SUBJECT: TRANSMITTAL OF NRO STAFF TECHNICAL EVALUATION OF
DUKE POWER COMPANY'S ASSESSMENT OF POSTULATED
JOCASSEE DAM FAILURE IMPACTS ON OCONEE NUCLEAR
STATION

Technical Review of Duke Power Company's Analysis of External Flooding of the Oconee Nuclear Station from Failure of the Jocassee Dam for NRR

ATTACHMENT: Breach Parameter Calculations Performed by NRO Staff

Figure 4. Jocassee Dam Elevation (Looking Downstream).

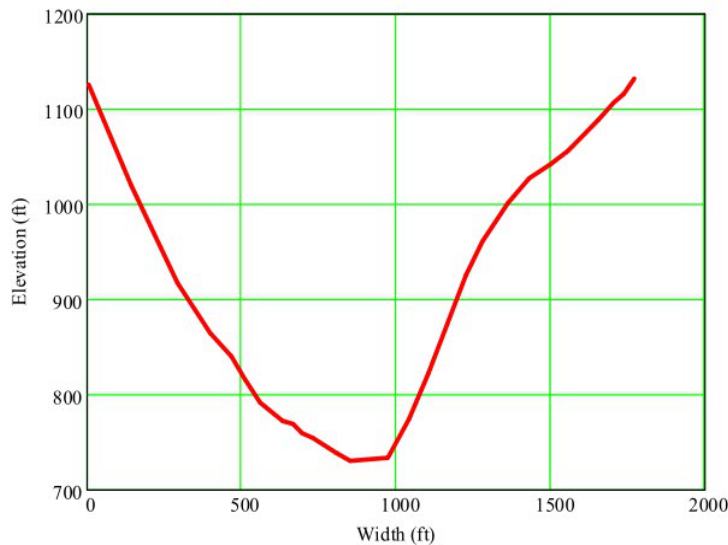
The drawing was scanned and the dam elevation figure was digitized to scale using computer software. Figures 4 and 5 show the results of this work.

Based on Figure 5, the average width of the entire dam (above elevation 730 feet) is approximately 967 feet and is 1100 feet above the elevation of 800 feet.

Figure 6. Trapezoidal Breach with an Average Width of 900 feet and a Bottom Elevation of 800 feet.

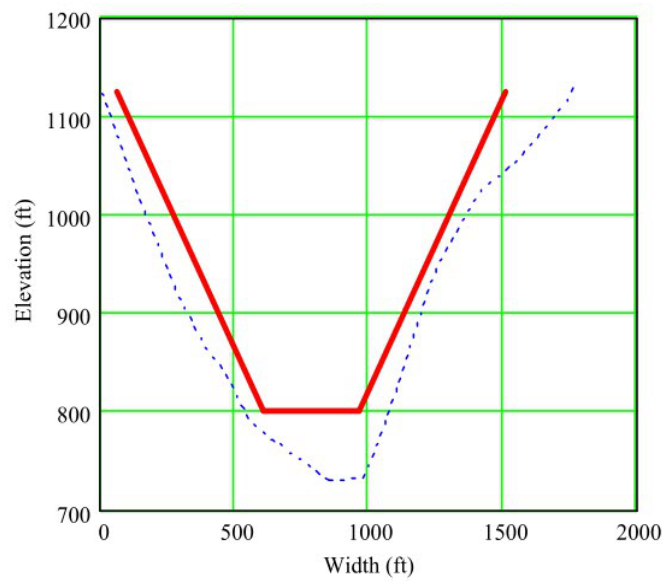
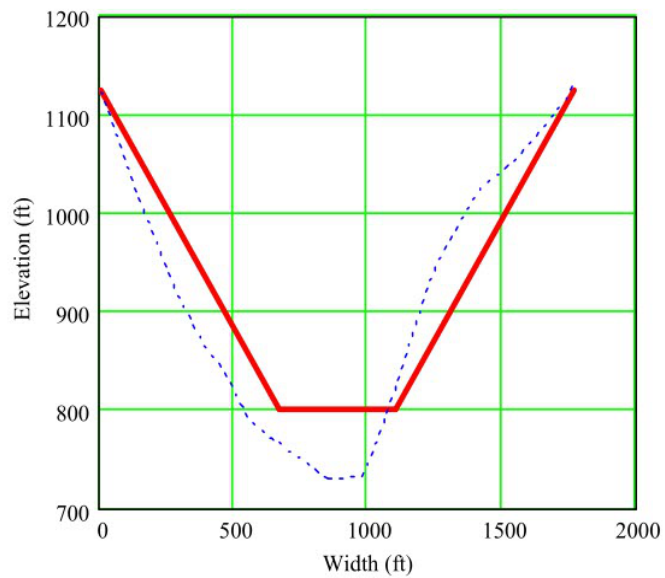
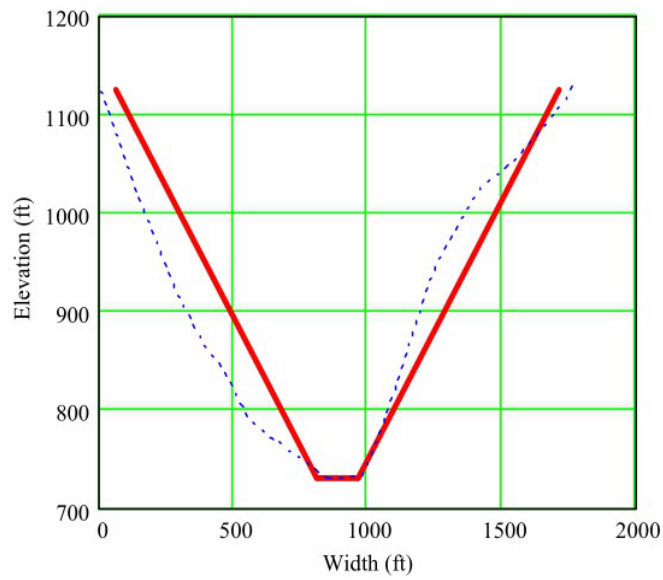
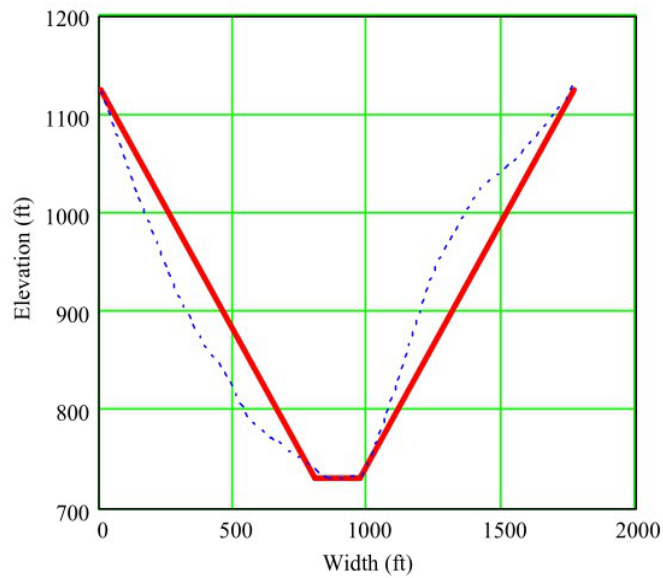
The dimensions of the trapezoidal breach were determined two different ways. First, the dimensions of the breach were chosen to match the average breach width of 900 feet as found from the regression equations. The second was to match the average width of the trapezoidal breach to the average width of the dam above the specified bottom breach elevation. Figures 6 through 9 shows the trapezoidal breach imposed on the dam elevation profile.

Based on these figures, NRO concludes that its postulated breach widths are physically consistent with the Jocassee Dam configuration.
